[Docket No. 2002–SW–46–AD; Amendment 39–12910; AD 2002–21–04]

Airworthiness Directives; Agusta S.p.A. Model A119 Helicopters

2002-21-04 Agusta S.p.A.: Amendment 39-12910. Docket No. 2002-SW-46-AD. Supersedes Emergency AD 2002-17-52, Docket No. 2002-SW-43-AD and EAD 2002-14-51, Docket No. 2002-SW-35-AD.

FIGURE 1

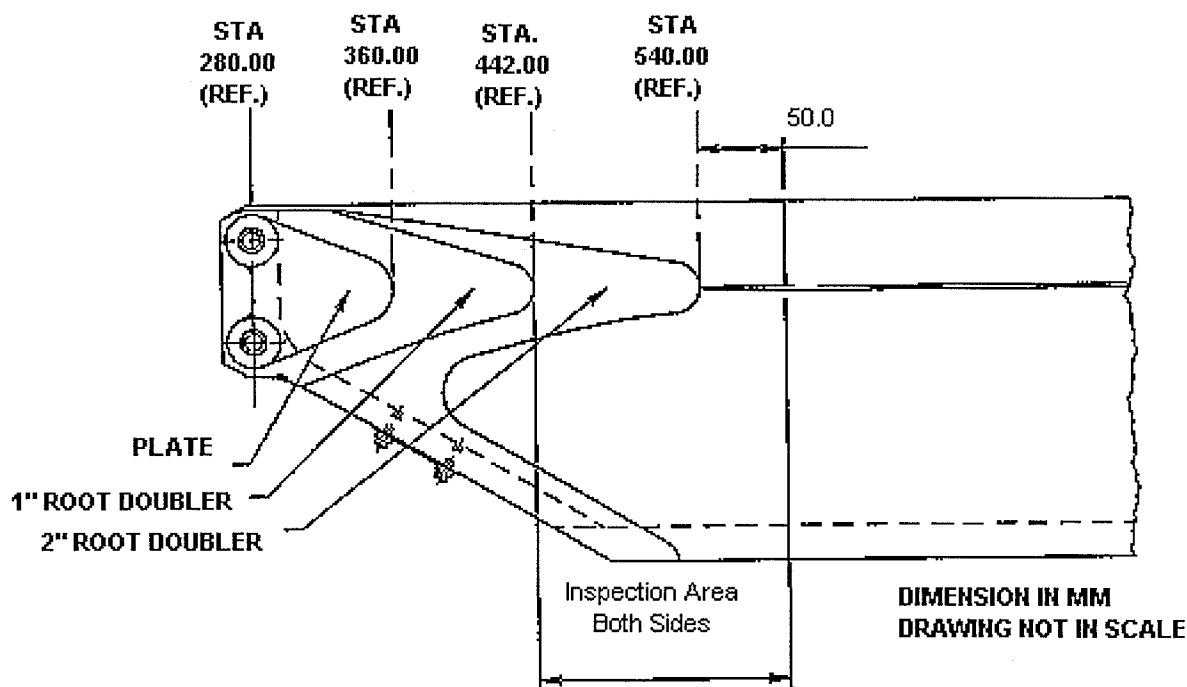
(b) Before each start of the helicopter engine, visually check both sides of each tail rotor blade for a crack in the area depicted in Figure 1 of this AD. An owner/operator (pilot) holding at least a private pilot certificate may perform this visual check and must enter compliance with this paragraph into the aircraft maintenance records in accordance with 14 CFR 43.11 and 91.417(a)(2)(v). See Figure 1:

Part Number 109-8132-01-111 Tail Rotor Blade

Note 2: Paint irregularities on the tail rotor blade may be due to a crack.
